CERTIFICATE OF APPROPRIATENESS

Property: 527 Frasier Street, Lot 3, Block 7, Freeland Neighborhood Subdivision. The property includes a historic 1,359 square foot, one-story wood frame single-family residence and a detached garage situated on a 5,000 square foot (50' x 100') interior lot.

Proposal: Alteration: Front Porch & Windows

Deferred from 5-18-2023 HAHC Meeting

Sept. 23, 2021 COA (Existing & Proposed Right Elevations)

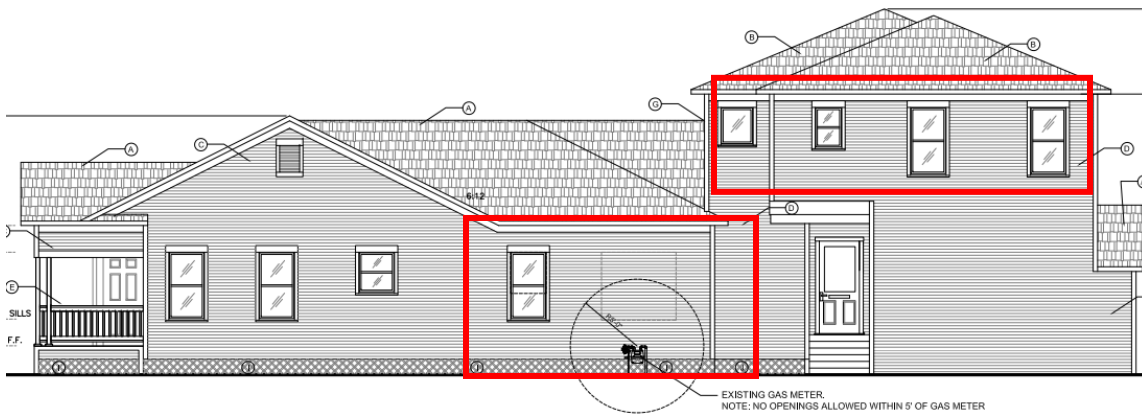
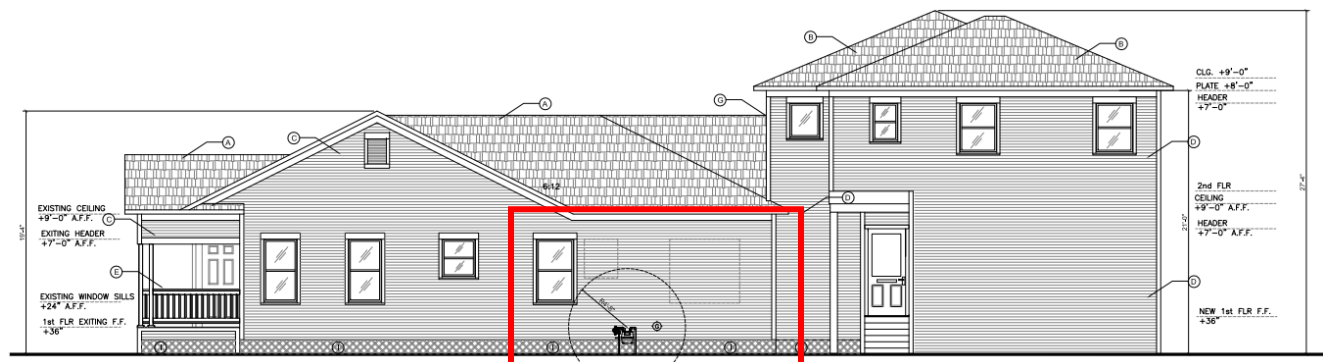
Recommendation: Denial of COA. Issuance of COR for work completed and as submitted with the condition that a single window opening of the same dimension and profile (inset & recessed) where a pair of windows were removed be made on right elevation and outside the radius of the gas meter.
